**Re: Conditional Use Permit Amendment Request
Tax Map 202, Lot 16
350 Little Harbor Road
Portsmouth, New Hampshire**

To: Portsmouth Planning Board and Conservation Commission Members
From: Bob and Sue Nalewajk, applicants
Re: Conditional Use Permit Amendment and Addendum
350 Little harbor Road
Portsmouth, NH 03801
Date: October 11, 2018

City of Portsmouth
 Application for Conditional Use Permit
 For Use, Activity or Alteration in a Wetland or Wetland Buffer
 [Zoning Ordinance – Section 10.1010 – Wetlands Protection]

Site Landscape & Planting Plan

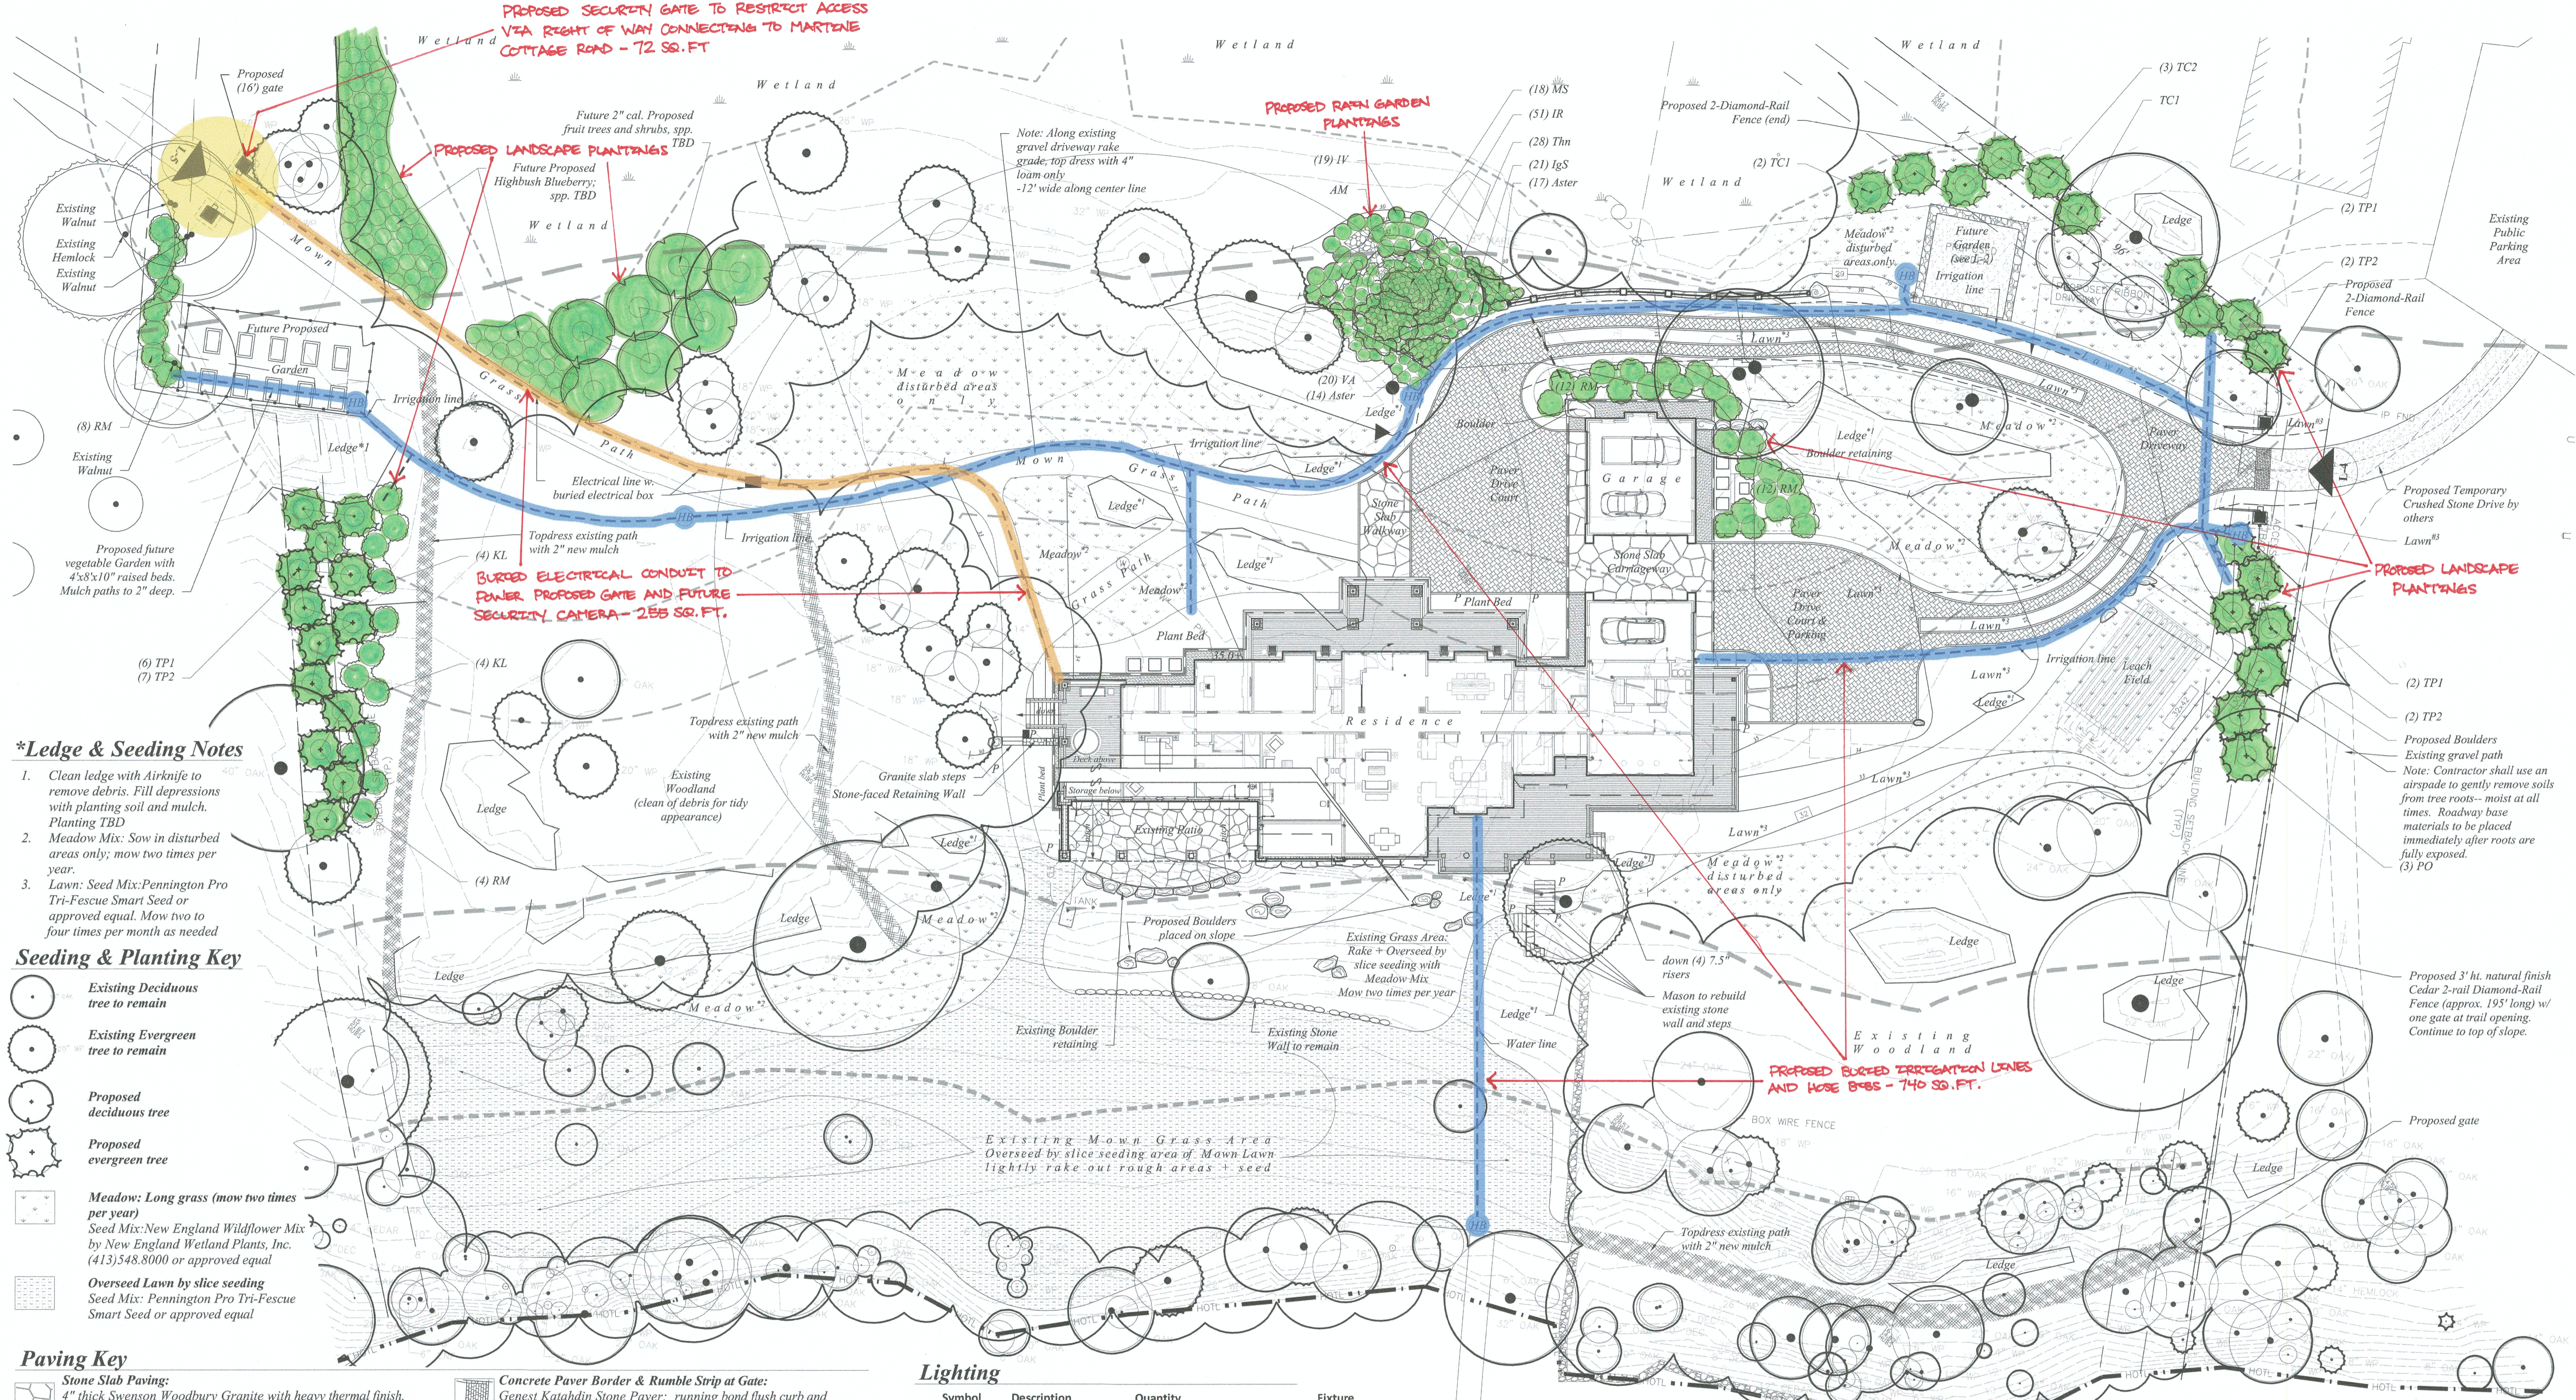
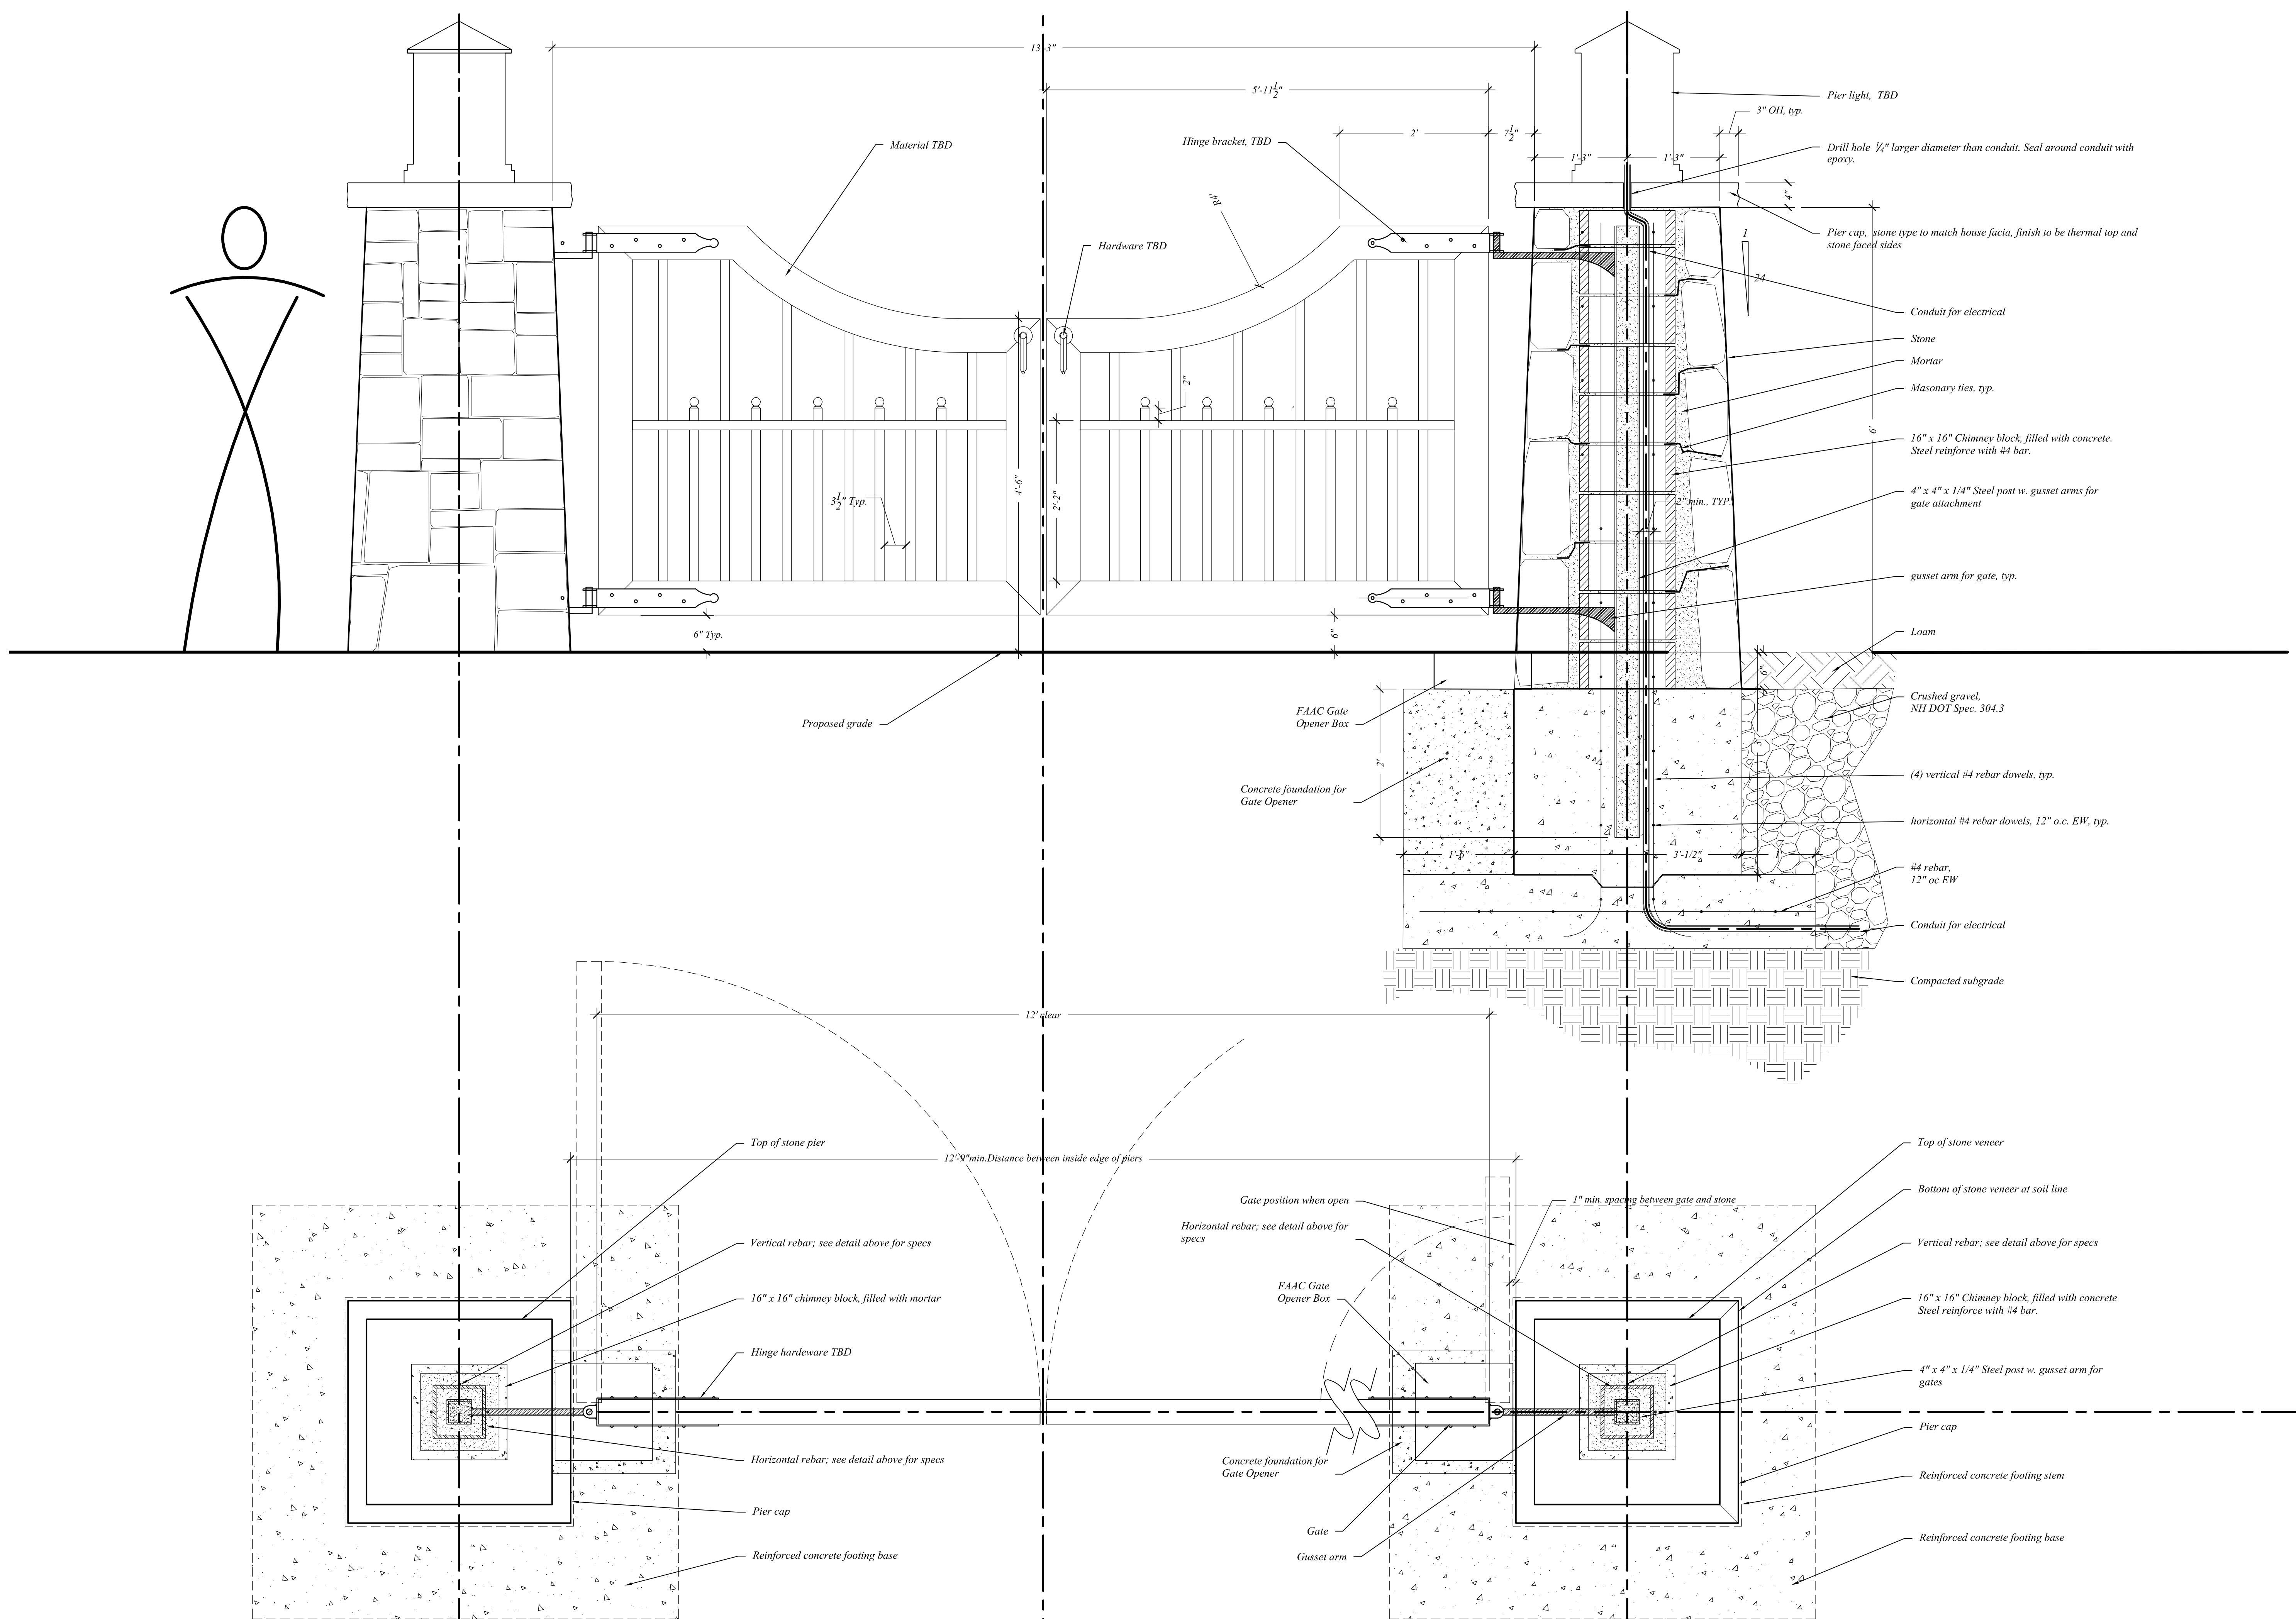
- Proposal of a security gate on the western side of the subject property associated with the legal access to the property from Martine Cottage Road. The gate is needed as historic use of the neighborhood (in particular the property known as Creek Farm), and historic use of Martine Cottage Road (by vehicles and pedestrians), has created a situation where the public is consistently entering the private property. The historic use of Martine Cottage Road and Creek Farm Road created a "circle" or "loop" in which vehicles and pedestrians could travel through the subject property (please see the attached Aerial Photo Exhibit and Photo Log). Subsequent to the purchase of the property, and re-development of the property, the owners have had to repeatedly ask the public to cease trespassing onto the property. The combination of the previously approved gate on the eastern side of the parcel, and the proposed gate on the western side of the parcel, will provide the property owners with the security they desire.

- Proposal of 255 linear feet of buried electrical conduit from the residential structure (under construction) to the location of the proposed gate. Electrical power to the gate is needed for operation, as well as a security camera that will be installed on the gate (255 sq. ft.).

- Proposal of 740 linear feet of buried irrigation line need to provide water to proposed landscaped areas/landscape plantings on the parcel, located as much as 180 feet from the residential structure. The irrigation line contains hose bibs, which are garden hose fittings where a traditional garden hose can be attached. Additionally, the irrigation line will allow for “soaker” hose to be attached to provide drip irrigation to the proposed landscape plantings. The drip irrigation will help insure the survival of the landscape/rain garden plantings and can be placed on a timer to water only when needed, an excellent water saving technique.

* PLAN REVISED 9/25/18 WITH CALL OUT NOTES RELATIVE TO CHANGES FROM 9/15/16 CITY OF PORTSMOUTH CONDITIONAL USE PERMIT APPROVAL. THE PLAN INTENT IS TO SHOW CHANGES FOR A CONDITIONAL USE PERMIT APPLICATION AMENDMENT REQUEST.
TOTAL AREA OF DISTURBANCE : 1,067 SQ. FT.
